813 Wallgrove Road, HORSLEY PARK, NSW
Lot 100 DP1268340

27/06/22
19-0108- Cond A16CC-Cert-01

SSD 5248-MOD-1

Design Certification – A16

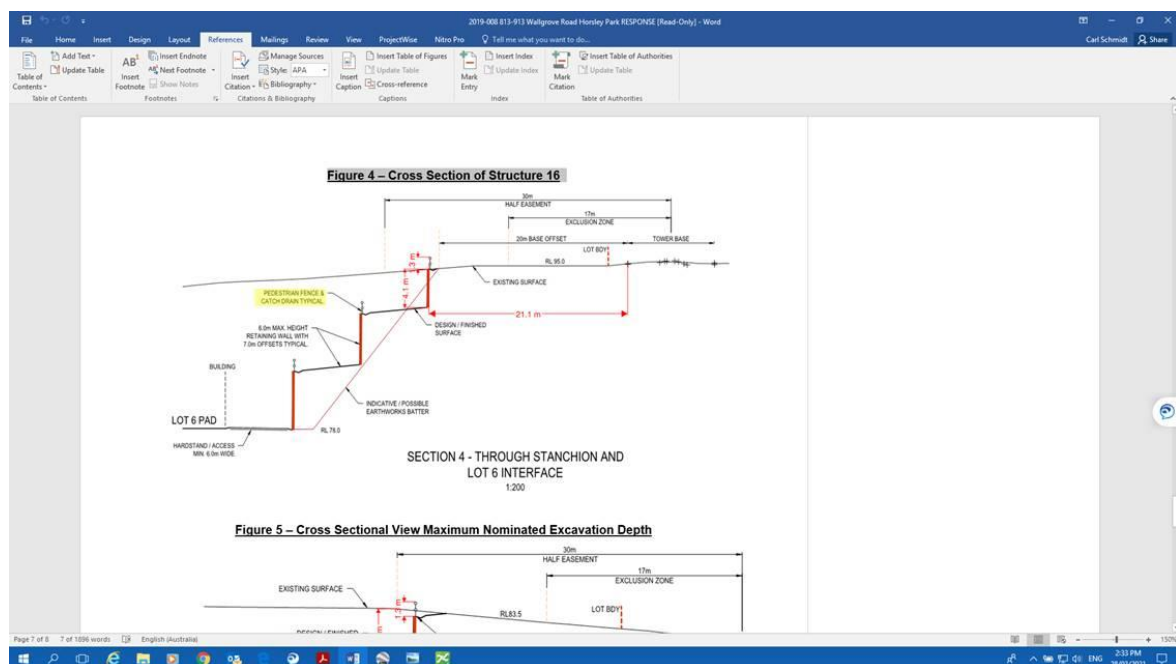
It is our understanding that the query relates to structure 16 on TL1C/1F. There is a new development proposed located adjacent to TL1C/1F between structures 13 & 16.

Structure 16 is located on top of a hill and the developer's designs indicate that they plan to cut back the hill toward structure 16.

The edge of the excavation appears to be approximately 20m from the base of the tower structure. And the total depth of the excavation is approximately 17m deep and will be achieved with a series of retaining walls (see details below).

From our review, structure 16 is a tension tower and has mass footings as detailed by TL141366. The mass footings extend to approximately 3m below ground level.

- i. Based on the details above, the excavation shouldn't adversely impact the tower footing capacity however it is important that the stability of batter/retaining walls are to be maintained.
- ii. Measures are to be installed to ensure that there isn't any soil erosion or instability of batter/retaining walls.
- iii. Note that the tower base needs to be accessible by vehicle.
- iv. The wall height should be reduced to 2.5m or it shall be of a design where people cannot stand on the top of the wall. 2.5m height would be the preference.

- i. The 2.5m height to the retaining is not a requirement however it would be preferred to maintain this maximum height of the walls.
- ii. TransGrid will accept retaining wall heights as proposed on the proviso adequate protection is provided along the length of the wall to prevent persons from falling.
